Addendum to the Final Drainage Report
(Crossspan Removal)
The Glen at Widefield Filing No. 10
El Paso County, Colorado

PCD File SF1921

Kiowa Project No. 19016

September 14, 2021

Amended Detention Basin Peak Discharge Exhibit

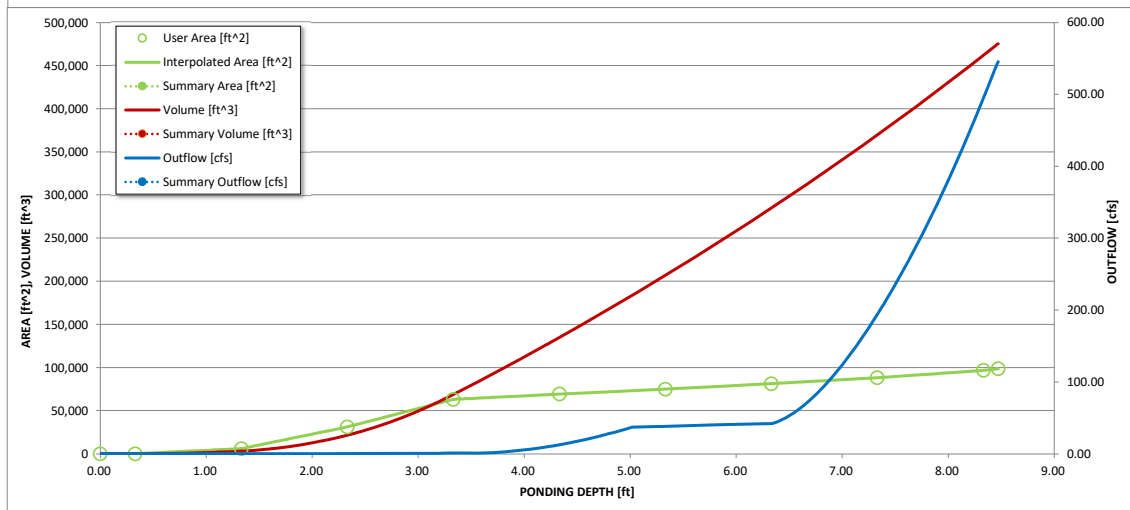
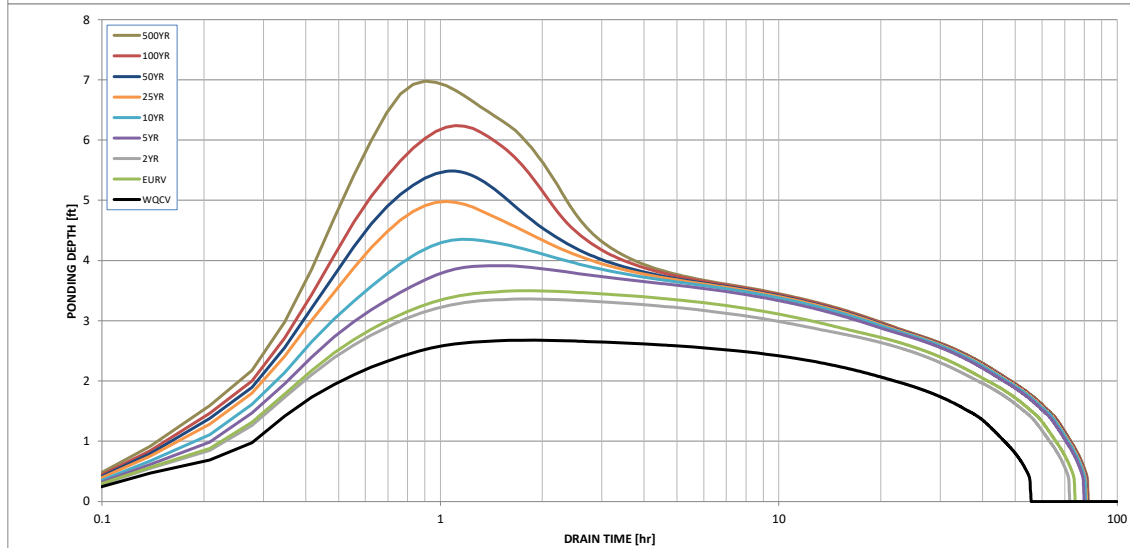
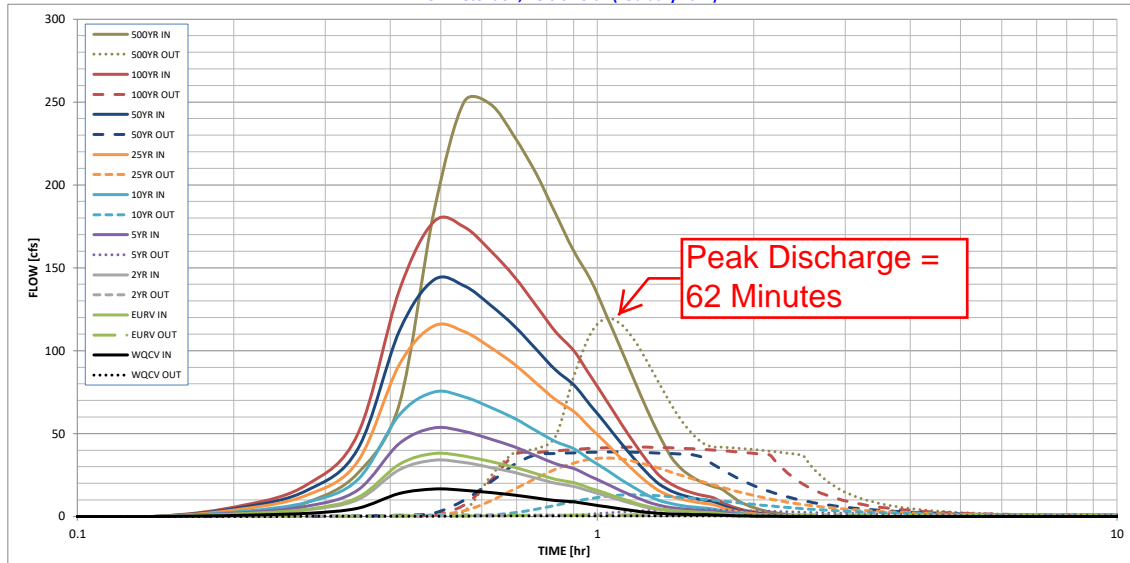
Modified Discharging Flows are now to be conveyed via existing concrete curb & gutter at Peaceful Valley Road and then to a riprap rundown for stabilization prior to entering an existing natural channel which serves the west one-half of Marksheffel Road along with some flows entering the channel from upslope landforms adjacent to the roadway corridor. This channel is trapezoidal and is fully stabilized. Flows from Sub-Basin 20a are expected to enter the channel well ahead of Peak Discharging Flows from Detention Basin 'D' (See Time of Peak Discharge Exhibit at Appendix).

Existing Trapezoidal Channel S of Peaceful Valley Road

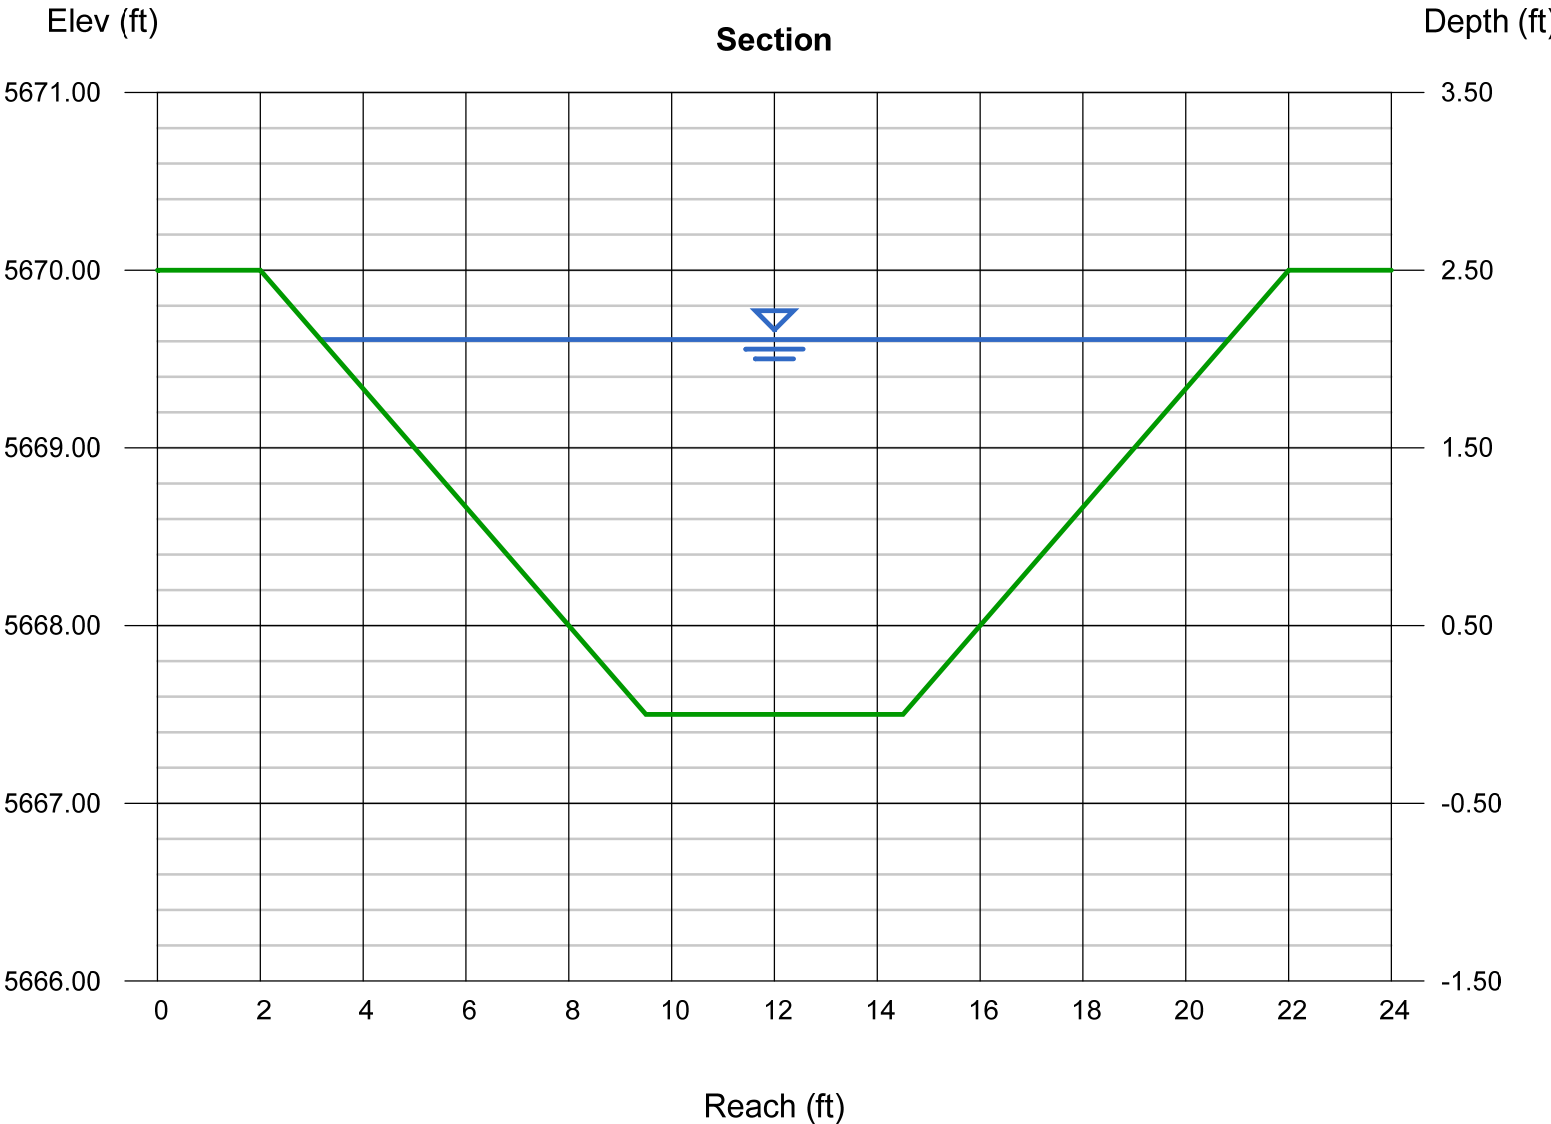
Design Point 10-2 increases from 130.4 to 132.9 cfs in the fully built out condition (Filings 10-12). The trapezoidal channel is sized for 175 cfs. Capacity is adequate to accommodate the 2.5 cfs increase.

Amended Trapezoidal Channel Conveyance (Adds 2.5 cfs for Major Event)

Amended Drainage Plan - Developed Conditions Onsite D-1

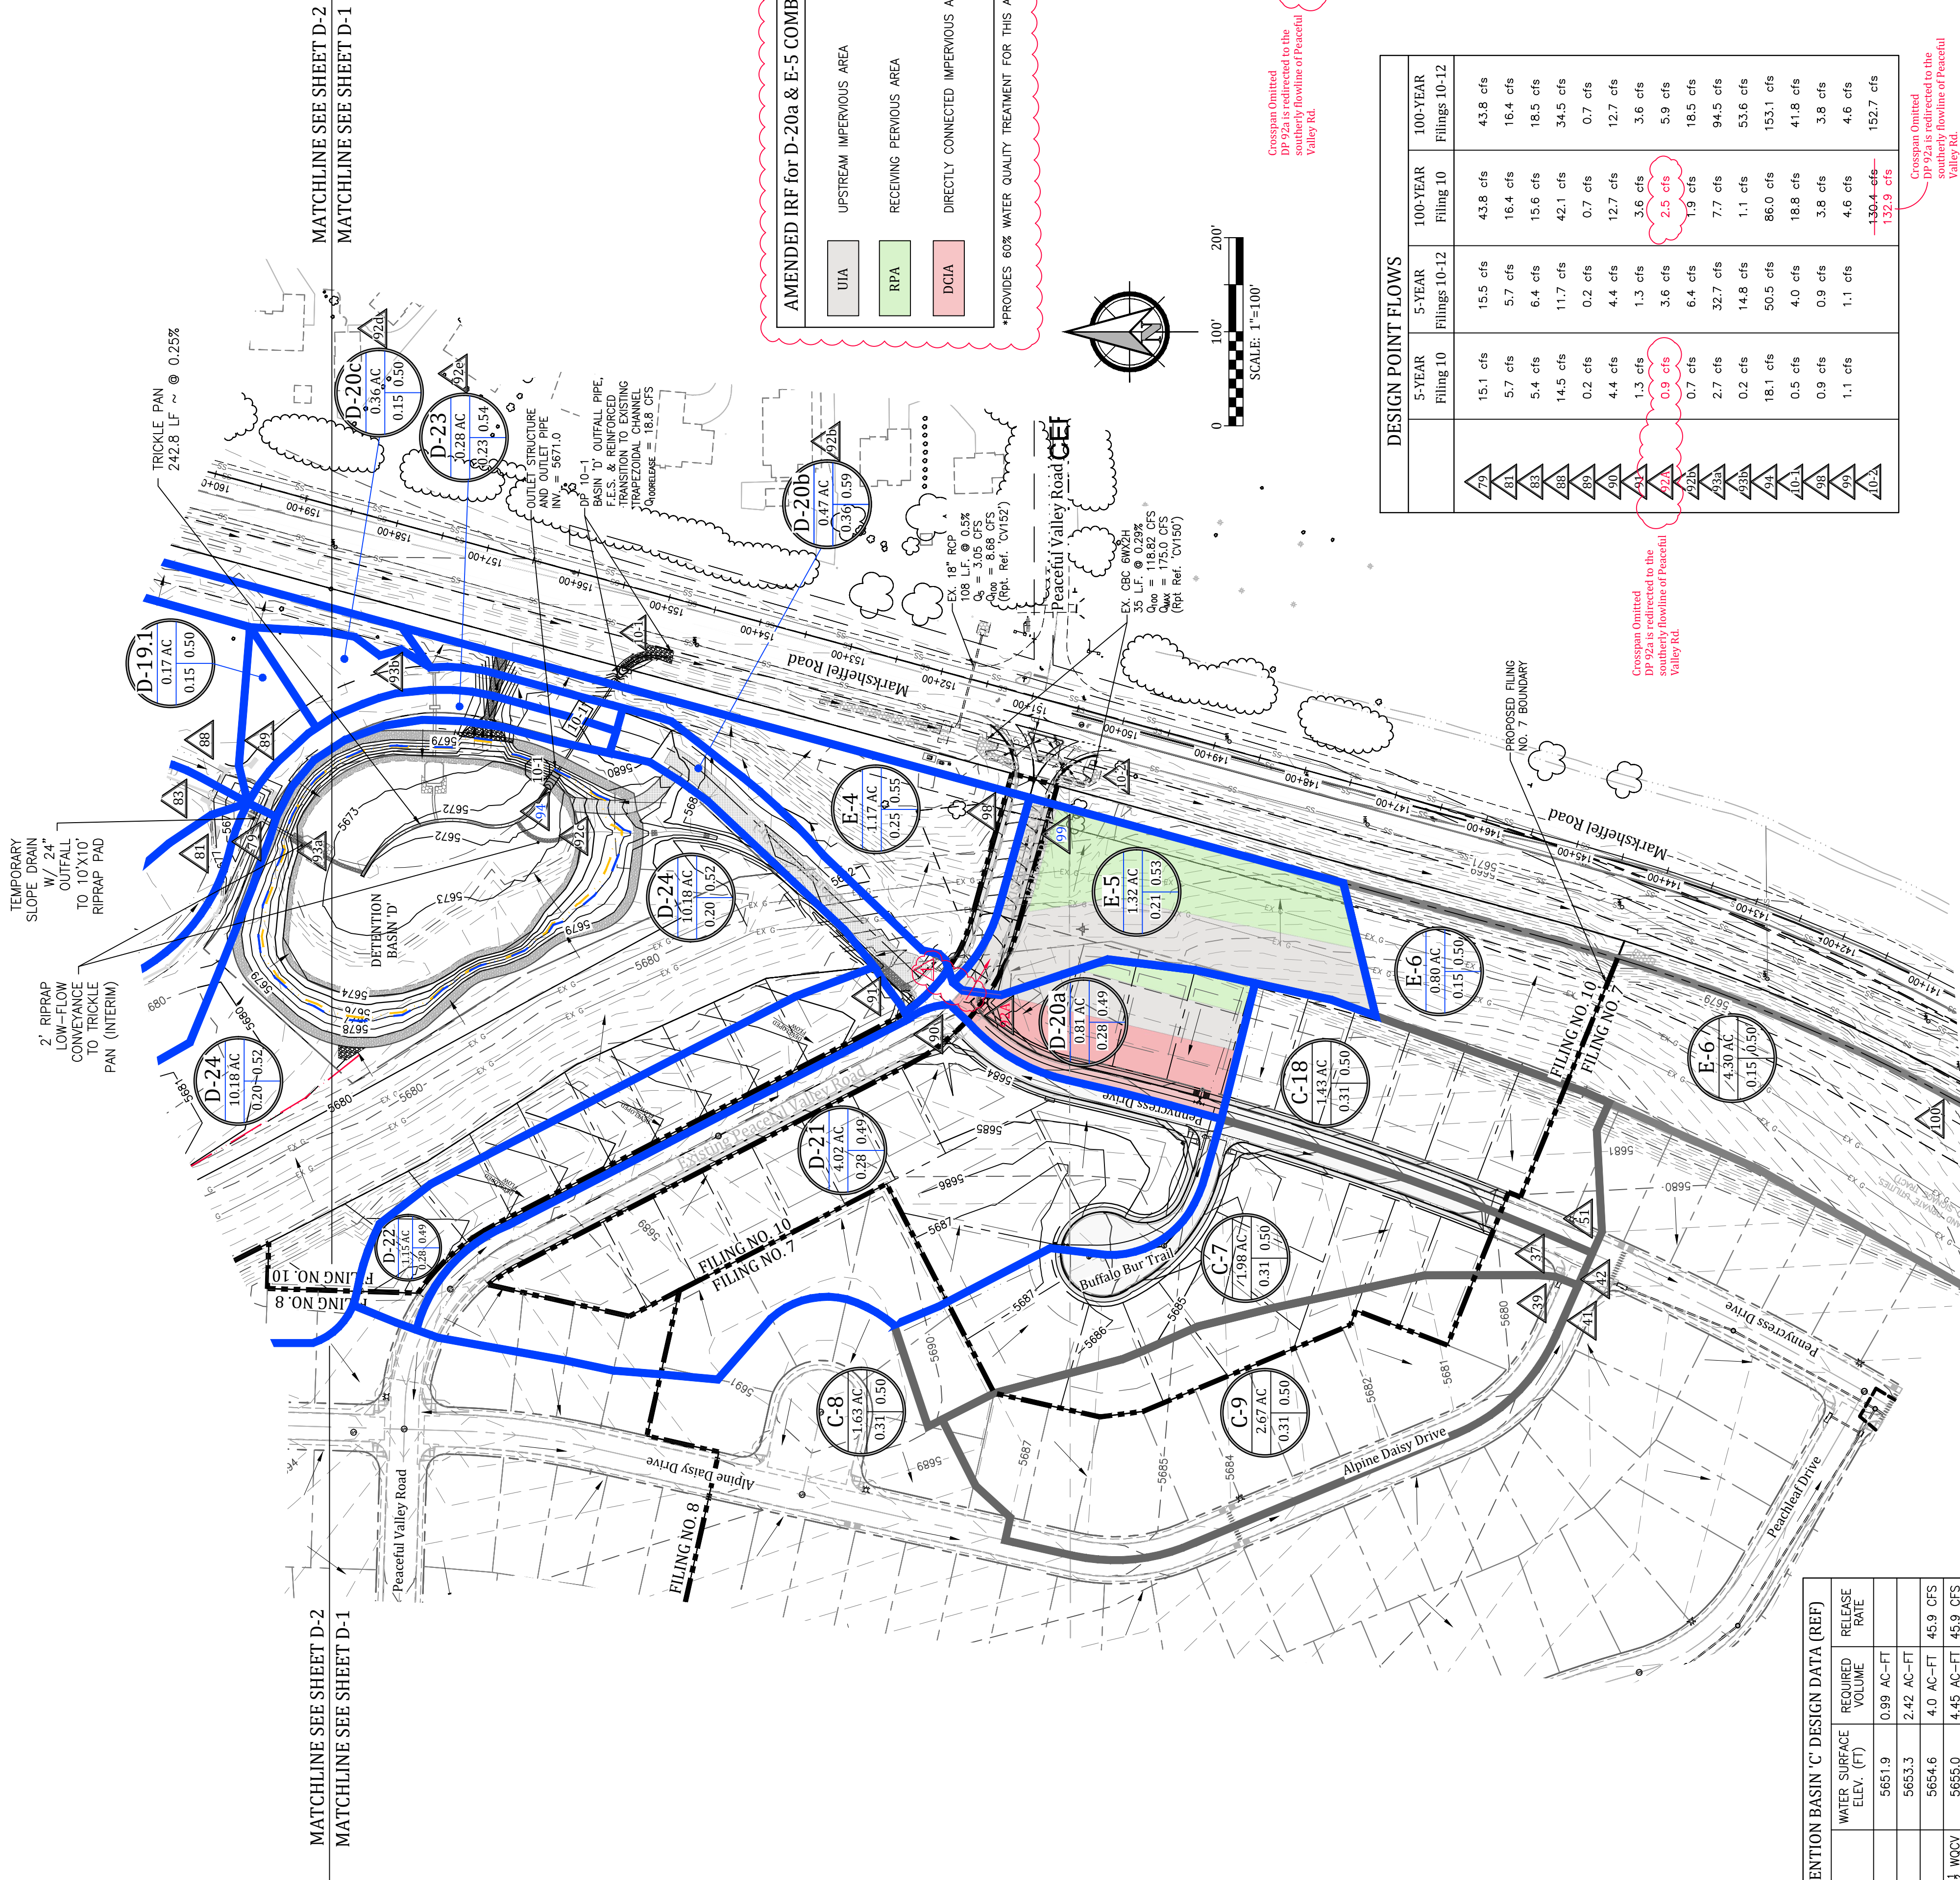
Peaceful Valley Road extends through the filing and connects to Marksheffel Road. This roadway was constructed as a part of The Glen Filing No 8, and will be improved further with this development through the addition of attached sidewalks and pedestrian ramps. A crossspan was originally planned to convey as much surface area as possible to the extended detention basin lying to the north (Detention Basin 'D'), but this pan has now been omitted to preserve the integrity of the existing roadway intersection.

The overall site drains to the West Fork Jimmy Camp Creek Drainage Basin at a point just upstream of Mesa Ridge Parkway. Sub-Basin D20a will drain east and then south to the existing roadside ditch at Marksheffel Road. As a result, the developed drainage pattern is slightly altered for the site. The modification to Sub-Basin D20a is reflected on Sheet D-1 in the Appendix.

Crossspan Limited to the southern boundary of Peaceful Valley Rd.

Crossspan Limited to the southern boundary of Peaceful Valley Rd.

Crossspan Limited to the southern boundary of Peaceful Valley Rd.

AMENDED IRF for D-20a & E-5 COMBINED*	
	UPSTREAM IMPERVIOUS AREA
	RECEIVING PERVIOUS AREA
	DIRECTLY CONNECTED IMPERVIOUS AREA

*PROVIDES 60% WATER QUALITY TREATMENT FOR THIS AREA
